MAY 2019

Specification change: RF2 series 2-pole force guided relays

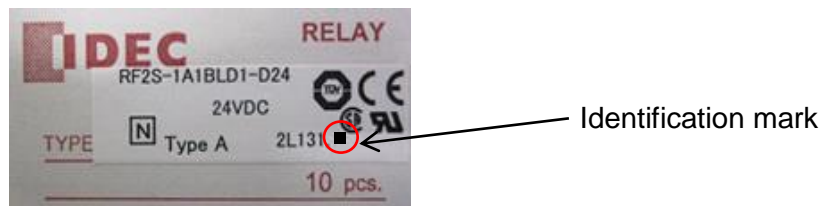
The electronic parts such as LED and diode will be changed as follows.

LED	Current	New
Off		 New LED and diode
On		 The LED illumination will be slightly brighter

Note: There is no other specification change. 1
